NESO reply to consultation comments

NESO acknowledged all the comments from SSE Generation and had a follow-up meeting to clarify their questions and concerns. The key discussion points and subsequent actions from the meeting are summarised as follows.

Appendix 1 – Extended simulation for overholding DC

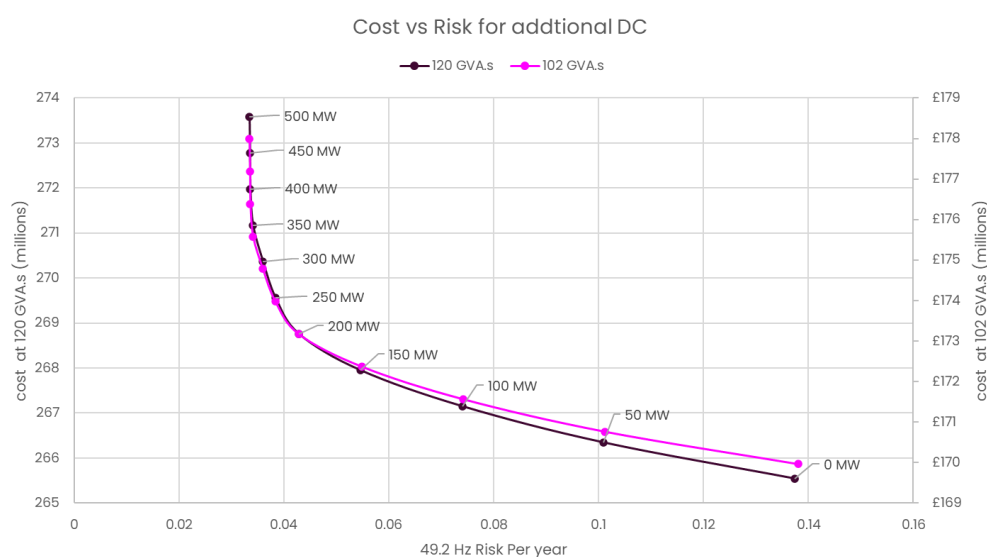
Based on the feedback from SSE Generation and similar comments from other consultation responses, We have extended our analysis in DC-L, increasing the additional volume from the current 300 MW to 500 MW, and have presented the data with a granularity of 50 MW. Our conclusion and recommendation remain unchanged, that the risk vs. cost analysis showed that 200 MW is a balanced option, covering most risks without significantly increasing costs. The updated analysis will be included in the final FRCR 2025 report when submitting the SQSS Panel and Ofgem. In the meeting, NESO also explained that significantly increasing the DC volume in a single attempt could

12	<p>Do you agree with the recommendation to procure additional DC-Low service provision by 200 MW ? If not, please explain why.</p>	<p>The recommendation was formulated by evaluating the procurement of an additional 100MW, 200MW, and 300MW of DC-low from the market. According to Table 6 in the FRCR Report 2025, the differences between these procurement levels are as follows:</p> <p>? Procuring 200MW costs an additional £1.62 million over 100MW, reducing the residual risk of a 49.5Hz event by 0.61 times per year and a 49.2Hz event by 10 years.</p> <p>? Procuring 300MW costs an additional £1.61 million over 200MW, reducing the residual risk of a</p>	<p>Thanks for the comments. We have conducted additional analysis to evaluate the effectiveness of different DC-L volumes. Please see the appendix for more information. Please note, with the additional analysis, our recommendation of procuring additional 200 MW DC-L remains.</p> <p>Please also note, since FRCR process establishment, the SQSS requires the transient frequency deviation outside the statutory limits, i.e. 49.5 and 50.5 Hz to be infrequent whilst FRCR sets out more rigid requirement on 49.2 and 48.8 Hz events. Between 200 and 300 MW additional</p>

Additional scenarios are simulated to cover 0 –500 MW additional DC holding with 50 MW step at 102 GVA.s and 120 GVA.s inertia requirement, shown as below. It can be seen that the two curves largely overlap and extend to the left side as the DC is increased to 500 MW. The incremental benefit becomes very small once the 200–300 MW range is surpassed. There is a discussion about whether 200, 250, or even 300 MW is the optimal choice. However, 200 MW remains a viable option.

Appendix 2 – Case study on minimum inertia policy's impact on 14th March 2025 event.

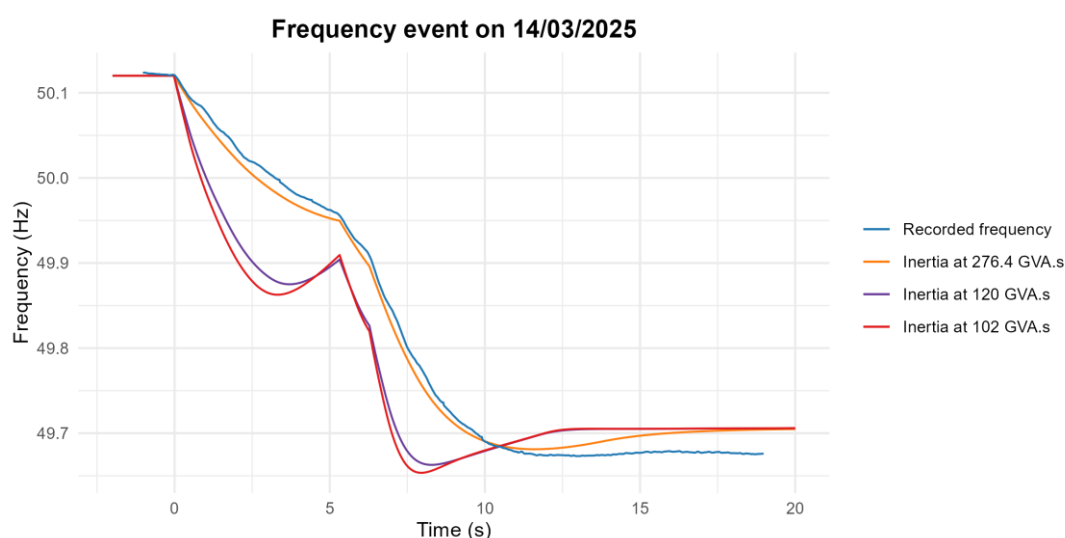
10	Do you agree with the recommendation to reduce minimum inertia requirement down to 102 GVA.s?	Determining an appropriate level of risk is not the responsibility of the non-network stakeholders. This decision should be made by NESO and Ofgem, based on their understanding of market liquidity, costs and their risk appetite, on behalf of consumers, concerning security of supply. The non-network stakeholders lack visibility into market liquidity and do not bear the responsibility for assessing what constitutes a reasonable level of risk for consumers.	Thank you for your feedback.
11	Do you agree with the recommendation to secure all BMU-only events (including	In recommending the 102GVA policy, NESO has opted not to account for simultaneous events. This decision appears to be based on the 1 in 9999-year residual risk, as indicated on slide 11 of the	Please refer to the appendix for the hypothetical analysis of 2025 simultaneous event.

<p>consequential RoCoF)? If not, please explain why.</p>	<p>consultation webinar slides, and the level of market liquidity.</p> <p>However, both the August 2019 and March 2025 events were simultaneous occurrences. We recommend revisiting the analysis supporting the exclusion of simultaneous events, particularly in light of the most recent event which occurred after the NESO's FRCR work, i.e. this consultation. If the NESO conclusion remains that simultaneous events should not be covered by reserve capacities, it is essential for NESO to provide a clear rationale for their decision.</p>	<p>If this event occurred in 2024, together with historic records, the occurrence of simultaneous events considered in FRCR would change from 3.5 to 3.67 per year. We might see a slight increase in 49.2 Hz and 48.8 Hz event probability. This however does not change our recommendation regarding simultaneous event security.</p> <p>Whilst securing for simultaneous events are not recommended in this year's FRCR, the additional procurement of DC recommended covers a reasonable volume of simultaneous losses to a degree at which NESO deems an appropriate risk vs. cost profile. With additional 200 MW DC-L procurement at 102 GVA.s minimum inertia, the residual risk of a 48.8 Hz event was reduced from 1 in 25.82 years to 1 in 30 years.</p>

Since the minimum inertia requirement sets only the bottom threshold and does not intentionally reduce inertia, the total system inertia of 276.4 GVA.s satisfies both the 102 GVA.s and 120 GVA.s minimum requirements. Therefore, there would be no expected differences in this event if the minimum inertia requirement were lowered to 102 GVA.s.

The figure below illustrates the expected frequency curves when the system inertia is either 120 GVA.s or 102 GVA.s. With lower system inertia, the frequency nadir will decrease but will still be contained within 49.5 Hz, while the stabilised frequency remains consistent.

Appendix 3 – Case study on minimum inertia policy’s impact on 22nd Dec 2023 event.

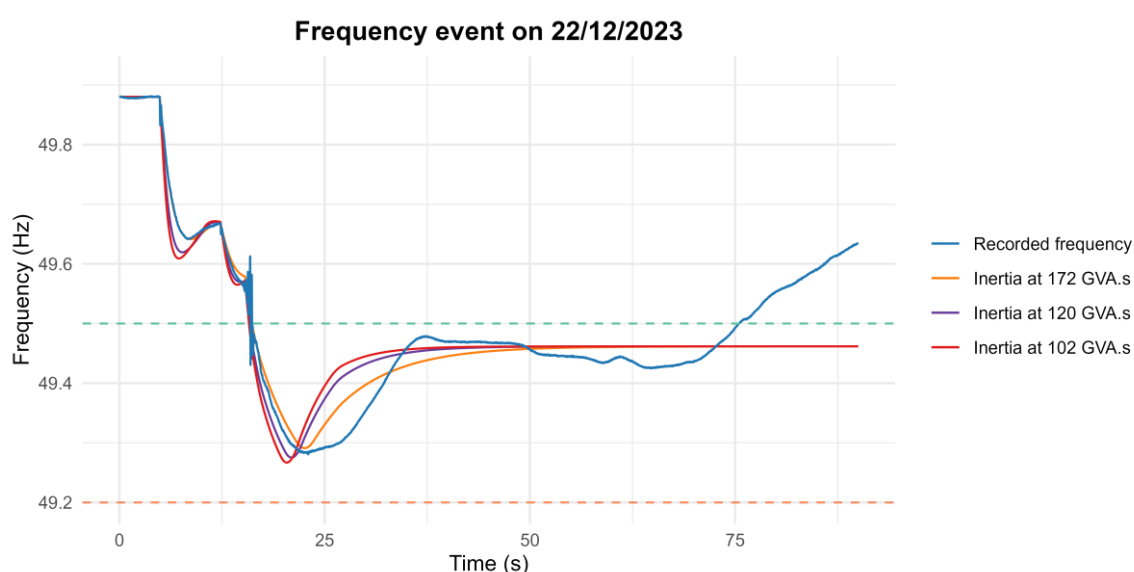
To address SSE Generation's question regarding how the system would perform if the historical events happened under a lower inertia level, NESO presented the hypothetical analysis to 2023 and 2025 simultaneous events, and explained how different inertia levels would have impacted the frequency response. The analysis showed that reducing inertia to 102 GVA.s would result in a slight drop in frequency nadir but still be higher than 48.8 Hz LFDD operation triggering level due to the additional response measures we would have procured under reduced minimum inertia level. We also explained that since FRCR 2024 policy, we have been holding additional DC-L responses, which helps cover majority of the simultaneous events even with lower inertia levels. FRCR 2025 recommends increasing the additional response from 100 MW to 200 MW.

The Frequency nadir difference between the 172 and 102 GVAs scenario is 0.026 Hz. None of the scenario will lead a breach of 49.2 Hz threshold. The minimum frequency at 102 GVA.s inertia level is 49.27 Hz.

At the time of the event, the live frequency control policy was FRCR 2023, which did not require any additional Dynamic Containment beyond the standard requirements. FRCR 2024 recommended holding an additional 100 MW of Dynamic Containment Low, while FRCR 2025 proposes holding an additional 200 MW. Increasing Dynamic Containment holdings would improve the frequency nadir.
